ADDENDUM NO. 001

Architects Project No.: 23042

Project Name: Ralston Apartment Renovations

CODE REVIEW & EGRESS PLAN

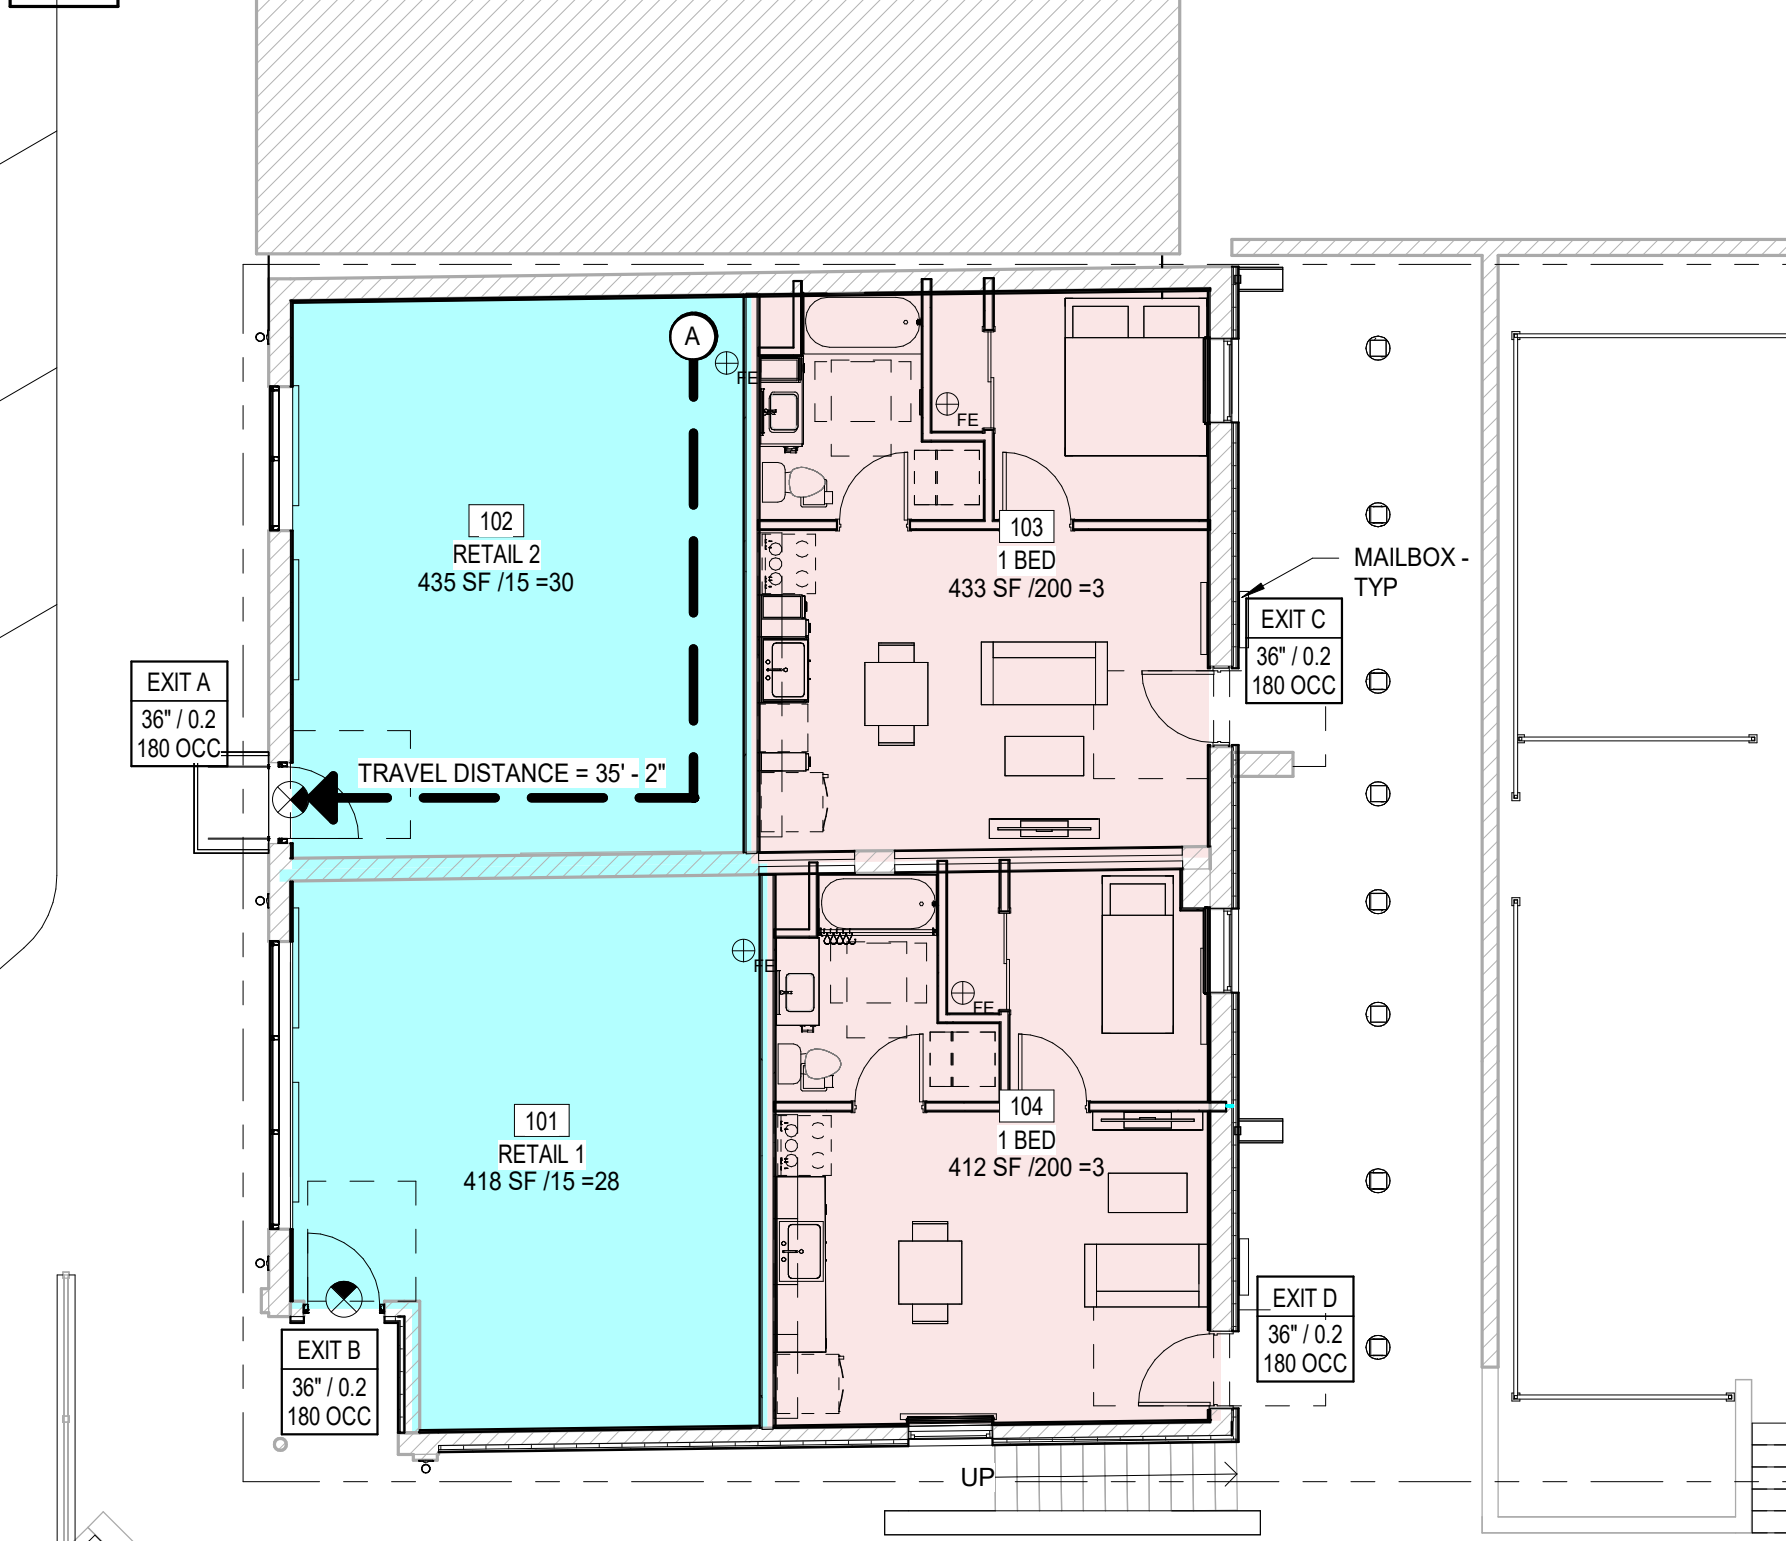
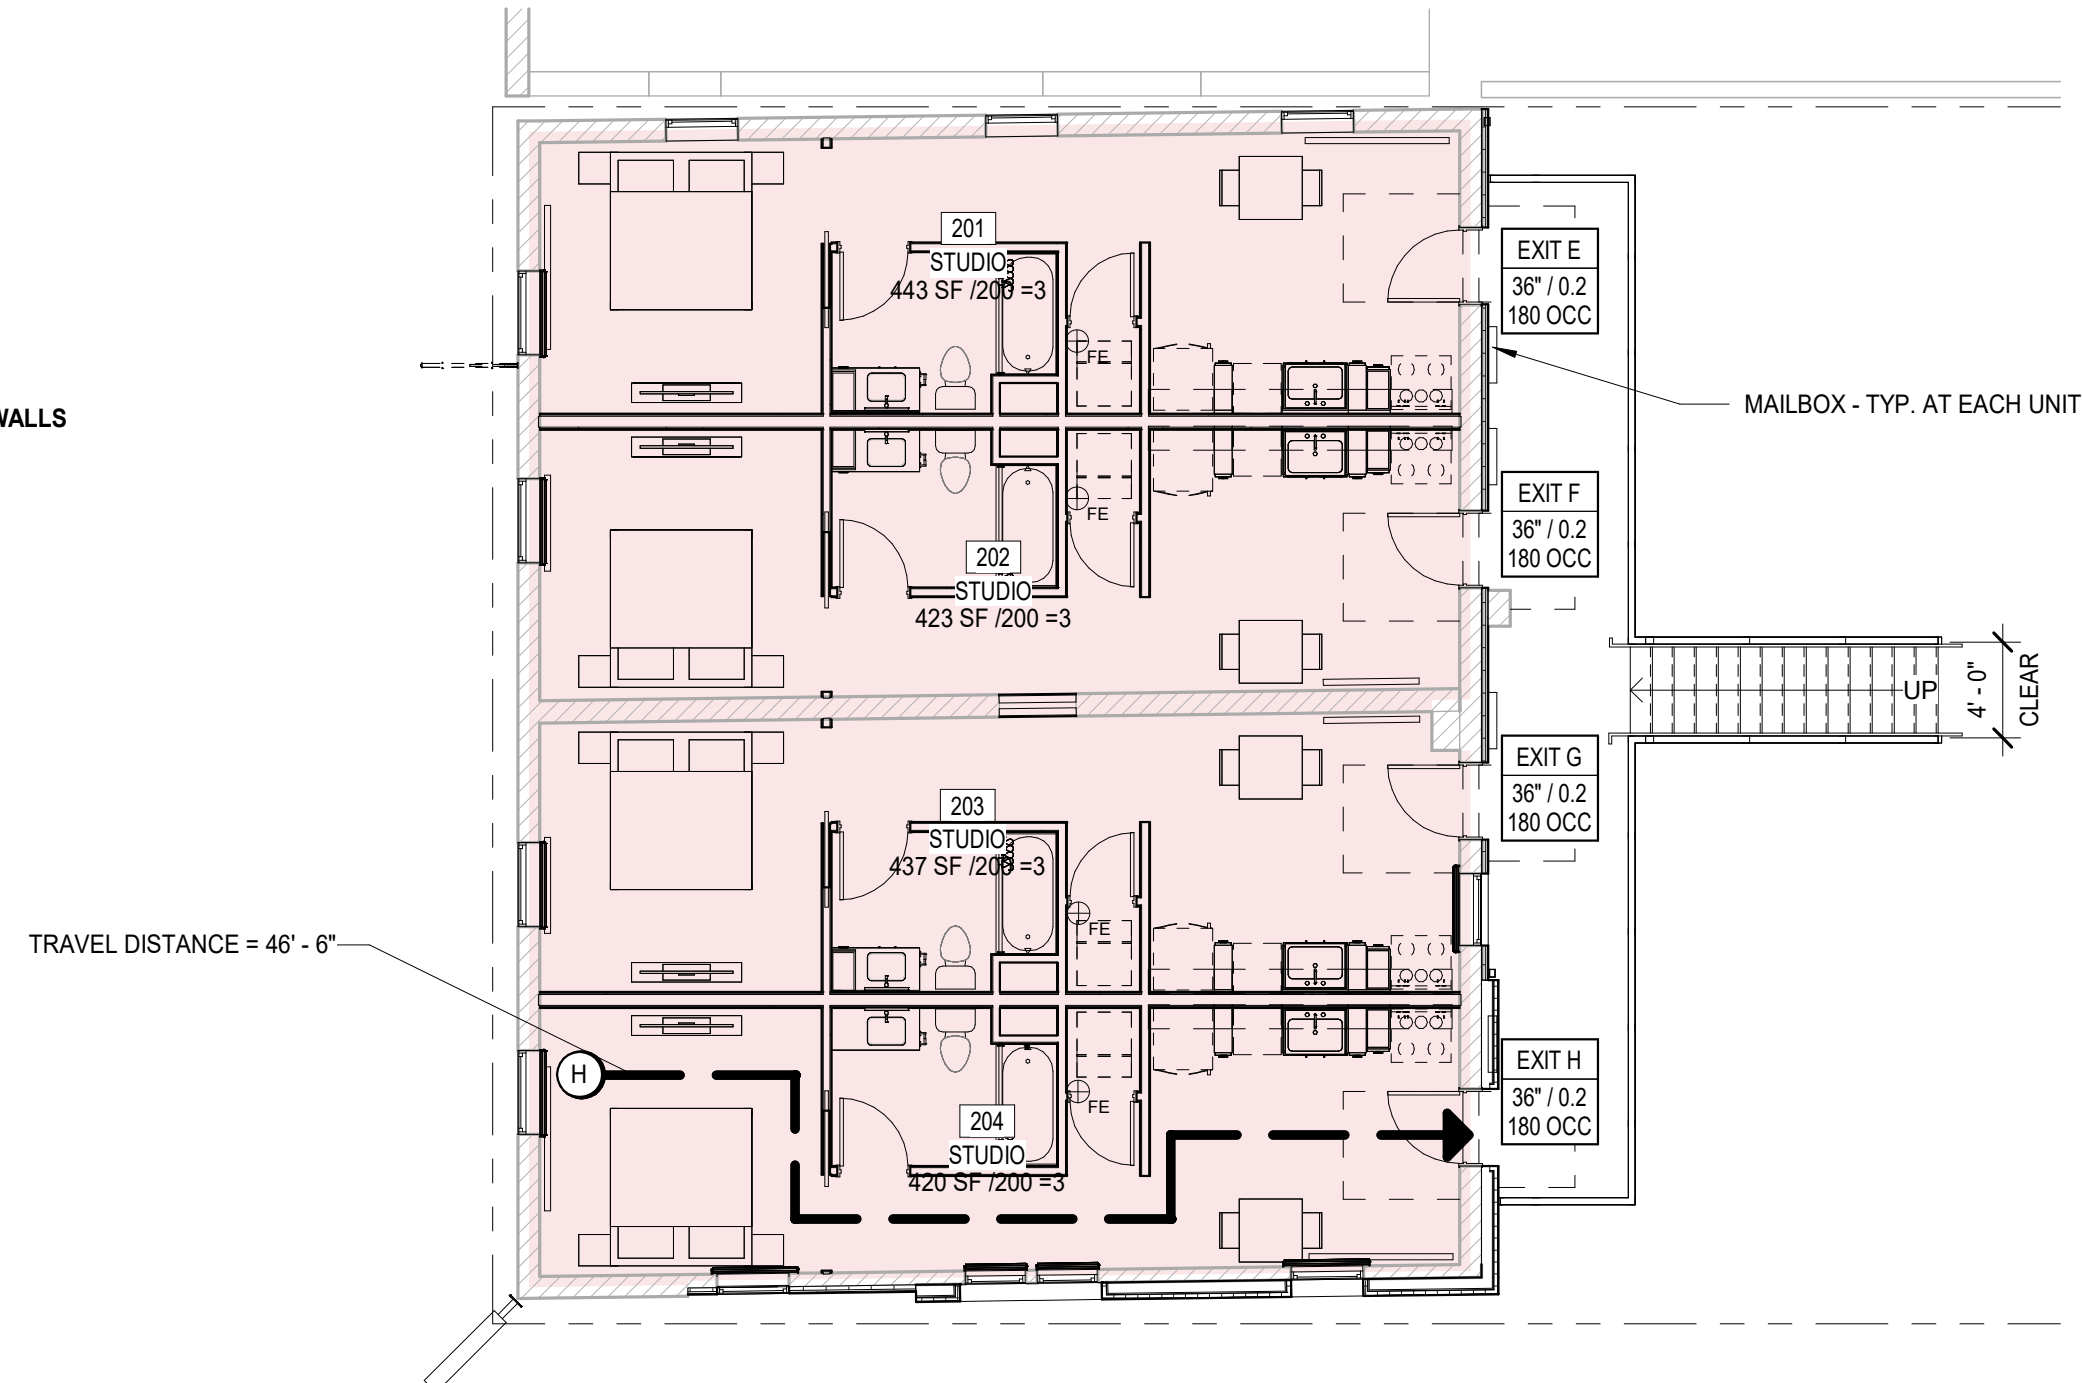
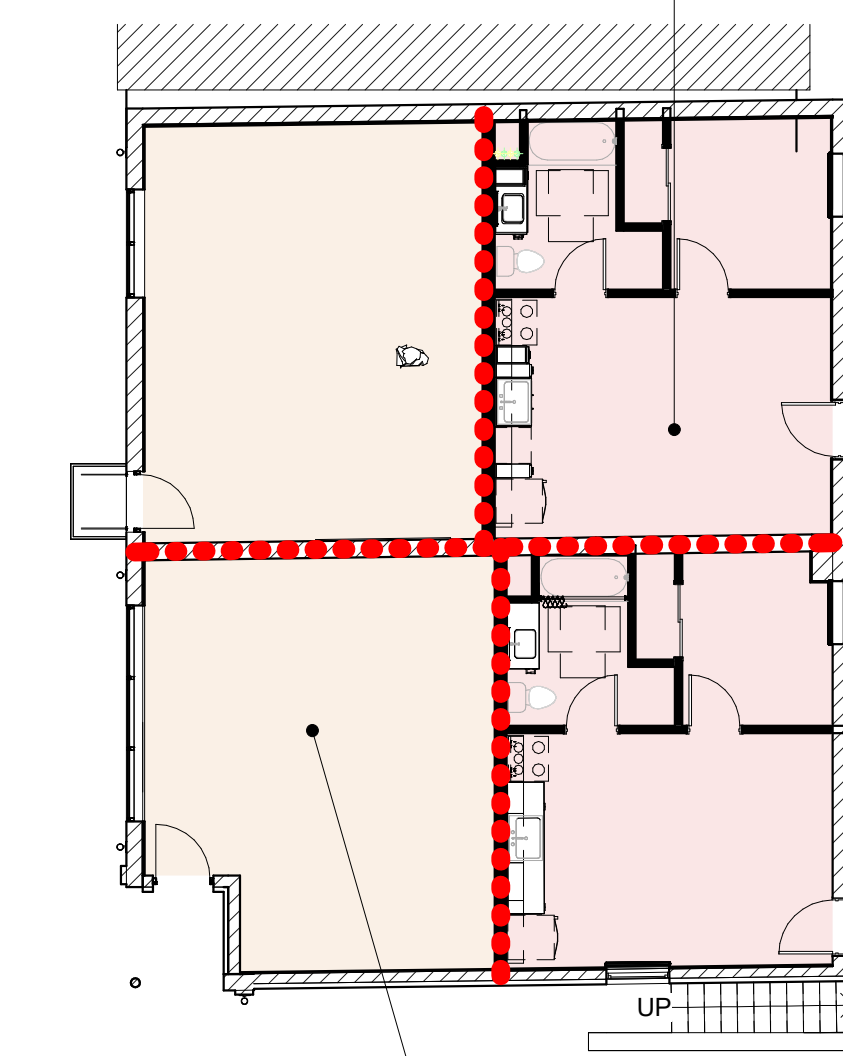
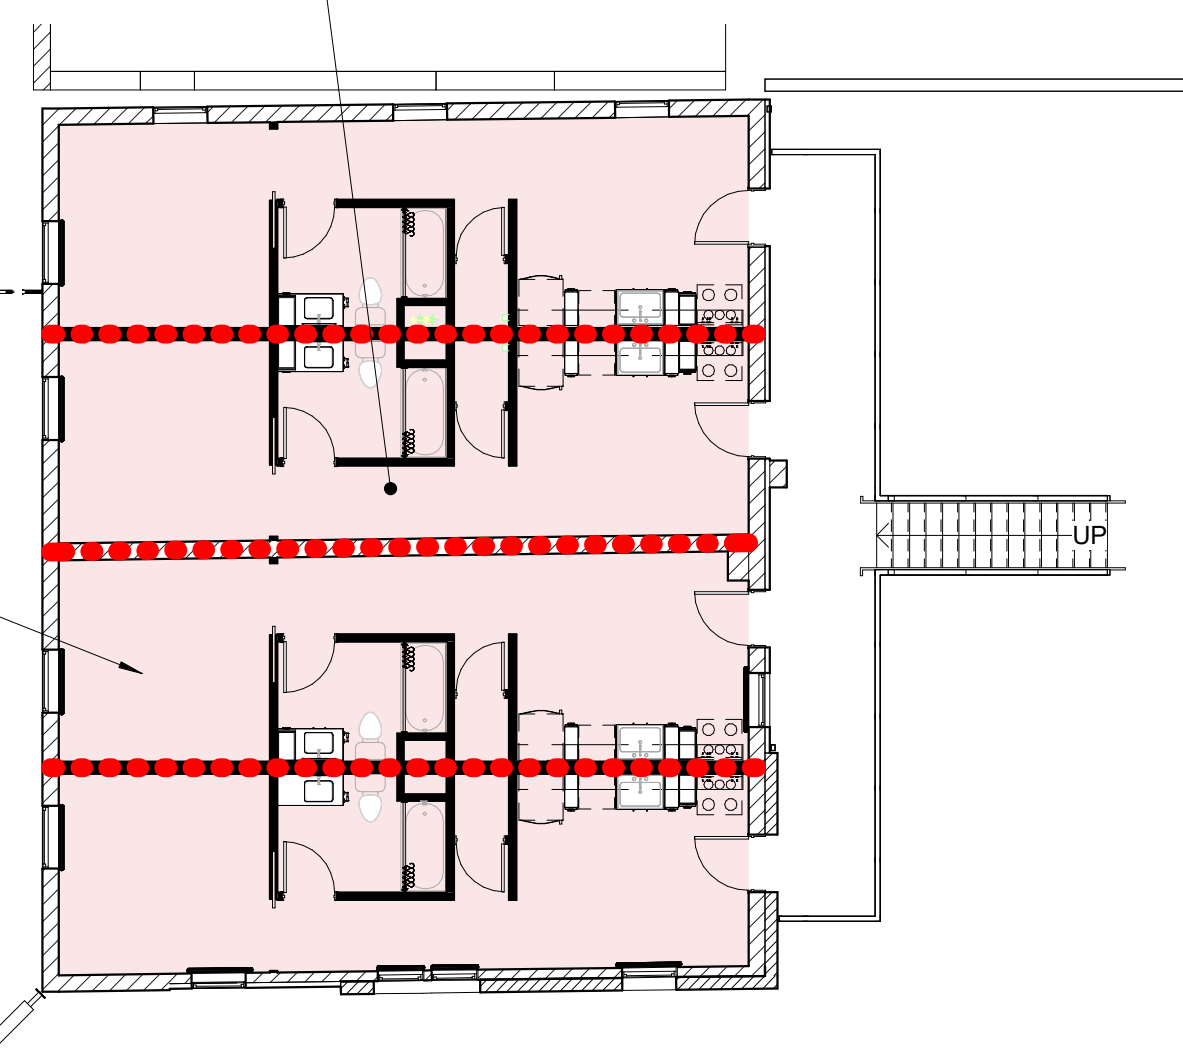
2. Sheet - G001 CODE REVIEW & EGRESS PLAN
 - a. Showing exit signs. Updated occupant load.
 - b. Updated detail 1 to show retail spaces as Assembly space for the retail bays.
 - c. General Cleanup.
 - d. Updated Area plan to include the retail areas.
 - e. Sprinklers updated to NFPA 13 to match MEP drawings.
 - f. Updated code information.
 - g. reversed swing direction for door 102.
 - h. Added door clearance graphics to door for clarification on code plan."
